Amendments/Additional Information

AMENDED

Your ref: NYM/2017/0453/FL

Burgate Farm.

Options for Sash's to open inwards

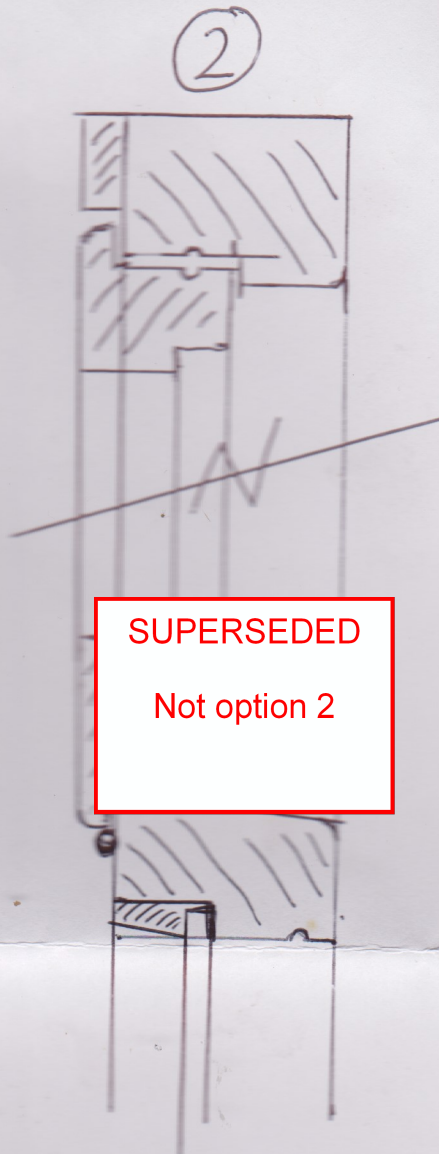
SUPERSEDED
Not option 2

Stormproofed.

AMENDED
Option 1 is
proposed

Here are two options for your consideration. However I would suggest that you were to go with Option N^o ①. I believe it is more in keeping with your project, it will look less clumsy and also will give equal if not better weather Protection.

I apologise for the delay, but knew that the joiner being a busy, practical man would take his time. Please find attached sections and we would go for drawing 1. They are to be inward opening partly to replicate what was there before, but also to enable easy opening by using a window pole. I hope that this now enables you to sign things off, as we are urgently wanting to fix windows etc. to make it water tight before proper winter weather.

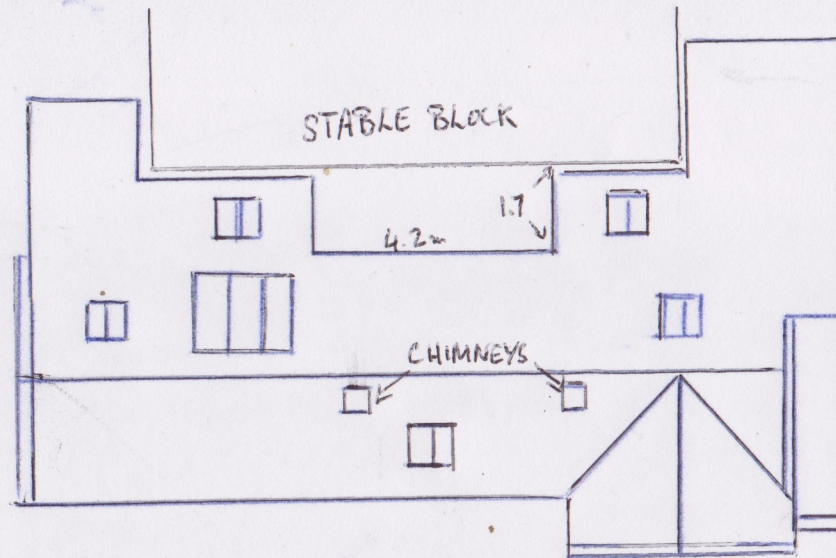
LOFT SPACE: I would agree with you over changing the roof line if it could be seen by anybody on the ground or from any adjacent buildings, but this is not the case. I attach a photo of the relationship of the building to the stables. I have taken it at the point that one might expect to see some difference, but in practice one cannot see far enough round the back of the stables.

The photo also emphasises the difficulty we have with having an internal gutter. We were aware of this from the outset, but unfortunately we are not in the income bracket to spend more than we already are. In an ideal world we would have built another loosebox building elsewhere since we use it for poorly calves as an isolation unit as well as stables.

Because none of it can be seen from anywhere, we think that block walling insulated and rendered would suffice, rather than stone as the rest of the building.

CROSS SECTION
OF LOFT SPACE WALL
DIVIDES.

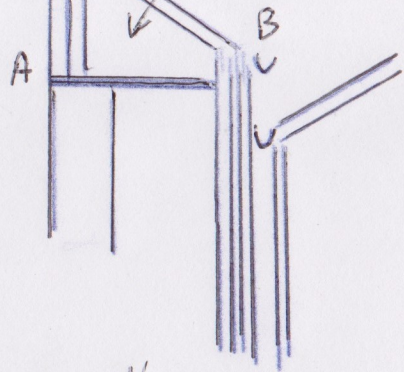
INSULATED BLOCK + RENDERED
WALL BETWEEN LOFT SPACES.

FIRST FLOOR PLAN
OF LOFT SPACE

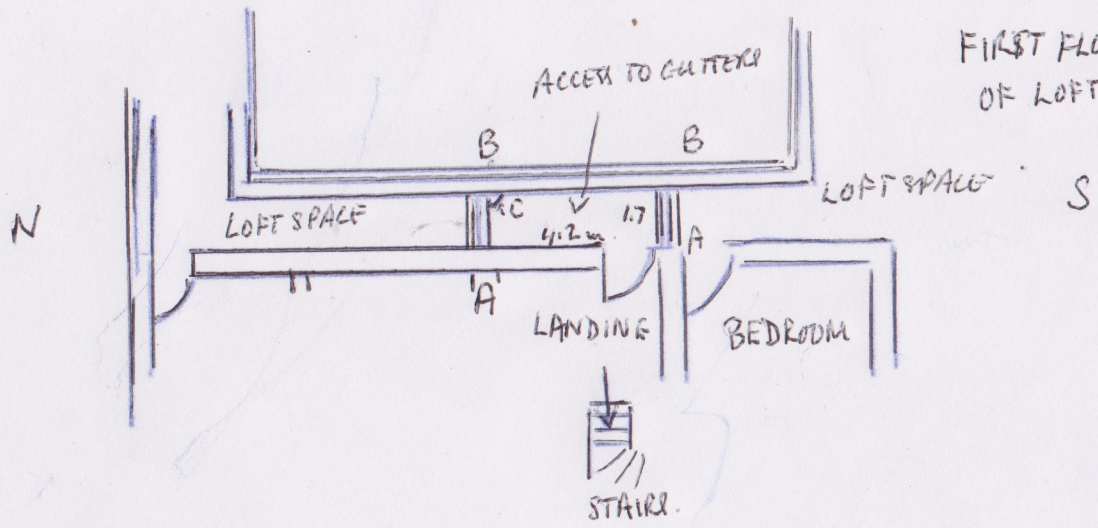
C drain hole to stable gutter.

I nearly forgot but the walls between the loft spaces are dictated by the load bearing walls and lintels on the ground floor. The northern A-B, will be above the northern block wall of the larder downstairs. The southern A-B is more difficult and will require a RSJ. The positioning of this is dictated by the lintels down stairs. Unfortunately there are a run of lintels but there is space at the planned 4.2 metres distance from the larder wall.
